**From:** [Yu, Olivia, EMNRD](#)  
**To:** [Andrew Parker](#)  
**Cc:** [Billings, Bradford, EMNRD](#); [Hernandez, Christina, EMNRD](#); "[Bradley Blevins](#)"; "[David Harwell](#)"; "[Jimmy Smith](#)"; "[Clabe Pearson](#)"; [r@rthicksconsult.com](mailto:r@rthicksconsult.com)  
**Subject:** RE: Advance Energy - 1RP-4953  
**Date:** Friday, June 29, 2018 7:28:00 AM

Thank you for the update regarding the status of completion of release characterization for 1RP-4953. In response to Mr. Hicks's email dated June 20, 2018, NMOCD will assume that the proposed removal of impacted soil above the caliche layer, before situating the drilling rig for additional vertical delineation, is valid based on professional judgement.

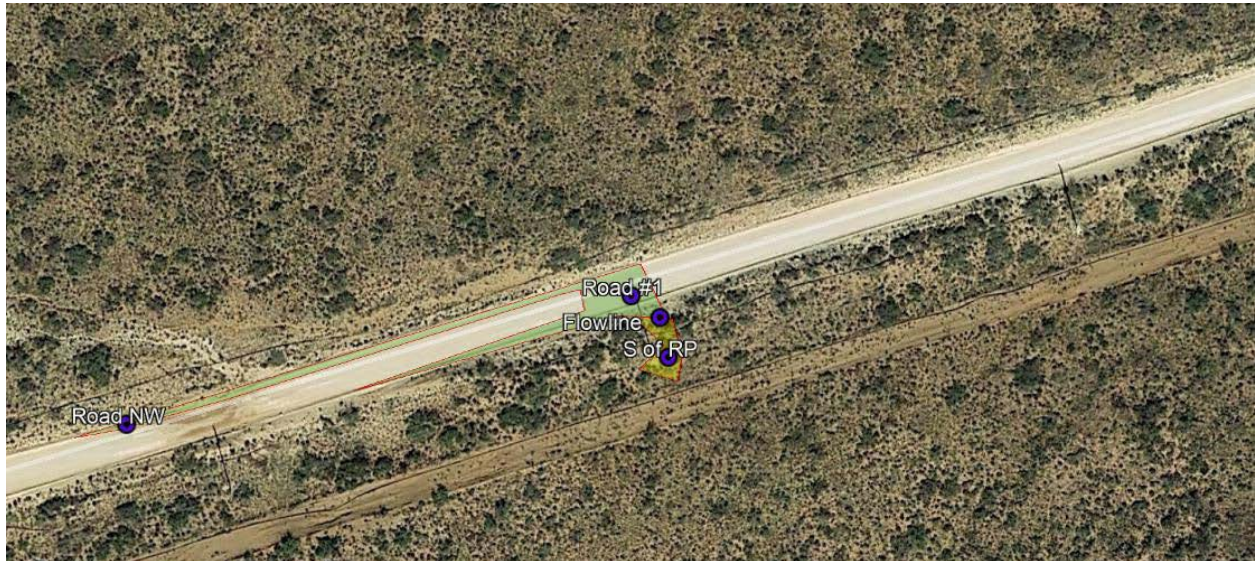
At the two release locations east of Battle 34, the presence of a pipeline, overhead electrical wires and uneven terrain at the release points will create logistical problems for a drilling rig at the desired locations. These access issues may be resolved by conducting excavation and removal with horizontal characterization to the top of caliche or 4-feet then conducting the drilling; The situation is shown in the images below

The Google image shows the spill footprint for the Latitude 32 Release, the pipeline scar to the south, the overhead power lines and the road. The image below shows the uneven terrain south of the road.
